QUAD CITIES NUCLEAR POWER STATION, UNIT 1

AMENDMENT TO FACILITY OPERATING LICENSE

Amendment No. 85
License No. DPR-29

SUPPORTING AMENDMENT NO. 85 TO FACILITY LICENSE NO. DPR-29

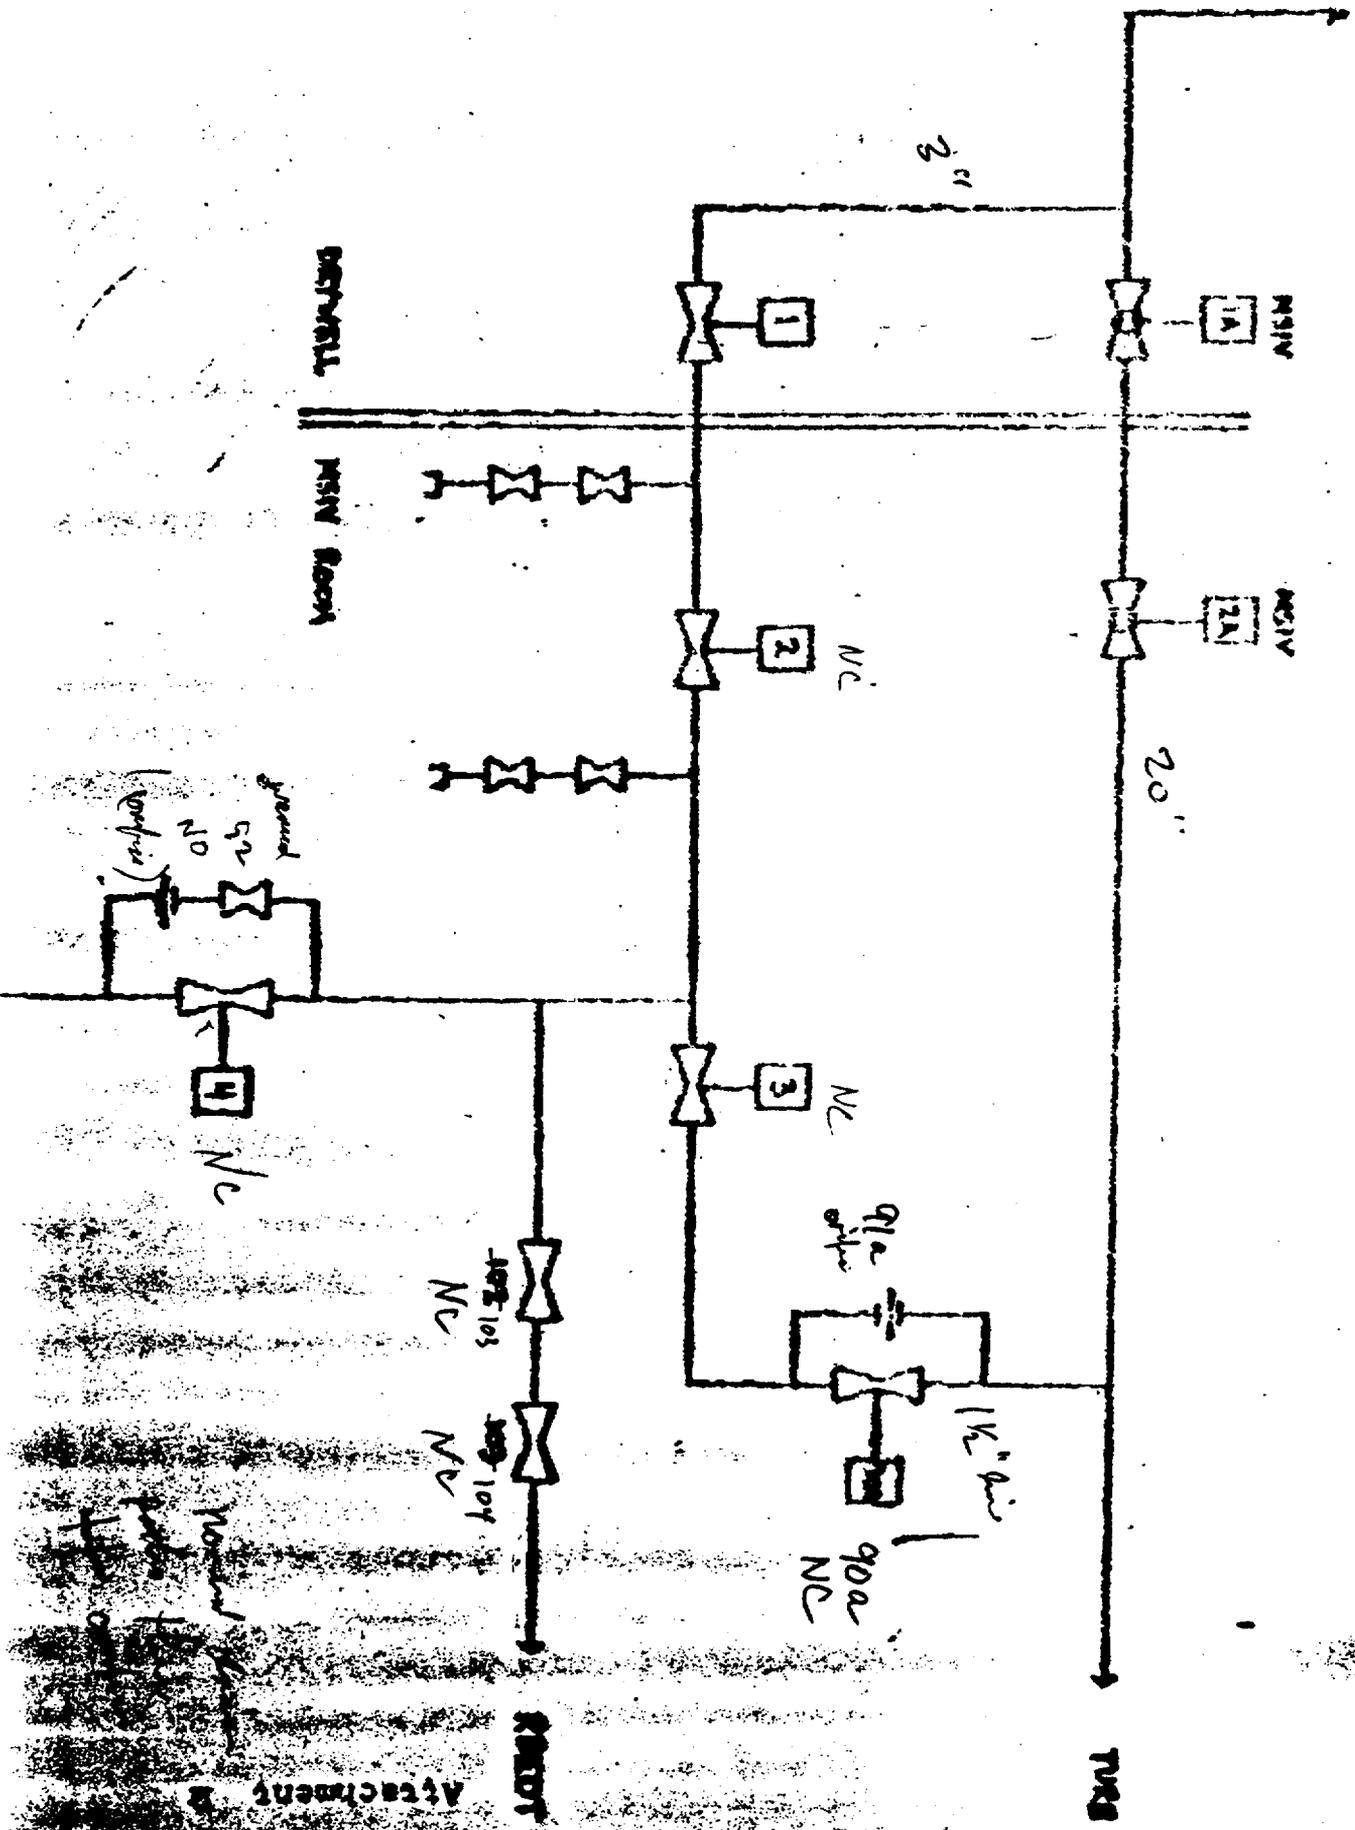
The attached drawing shows the two containment isolation valves for the three-inch main steam drain line. These valves are MO-220-1 and MO-220-2 (designated valve numbers 1 and 2). The licensee's basis for plant operation with valve MO-220-1 inoperable is as follows:

1. The outboard main steam drain isolation valve, MO-220-2, has been demonstrated to have an acceptably small leakage rate. This valve will close upon a Group I isolation if open. It is normally closed during operation.

2. Until MO-220-1 valve is restored to operability, valves MO-220-2, 3 and 4 will be verified closed after each valve closure.
3. Technical Specifications 3.7.D.2 acknowledges that the unit may be safely operated with only one valve in the isolated condition. Valve MO-220-2 will normally be closed during reactor power operation; it needs to be opened only during unit startup to drain the main steam lines or following a Group I isolation to allow movement of the MSIVs.

4. Downstream of the 1 and 2 valves, the leakage path leads only to the main condenser or to the other main steam lines and the RBEDT. Two other valves, normally closed valves MO-220-3 and MO-220-4, prevent flow through these paths. Any leakage through the 2 and 4 valves together or 2 and 3 valves will be very small.

Following our review of the licensee's proposal, and discussions with the licensee, we have determined that Unit 1 may operate with valve MO-220-1 inoperable, subject to the following new TS requirements:

1. Valve MO-220-1 will be restored to operability no later than startup after the first Cold Shutdown following a 30-day period after December 21, 1982.
2. While valve MO-220-1 is inoperable, valves MO-220-2, 3 and 4 will be verified closed after each closure.
3. During operating Cycle 7, until valve MO-220-1 is restored to operability, valves MO-220-2, 3 and 4 will remain closed, except that when the unit is in the Startup/Hot Standby Mode, valve MO-220-2, 3 and 4 may be opened as needed to drain the steam lines, or as needed after a Group I isolation to clear the isolation.
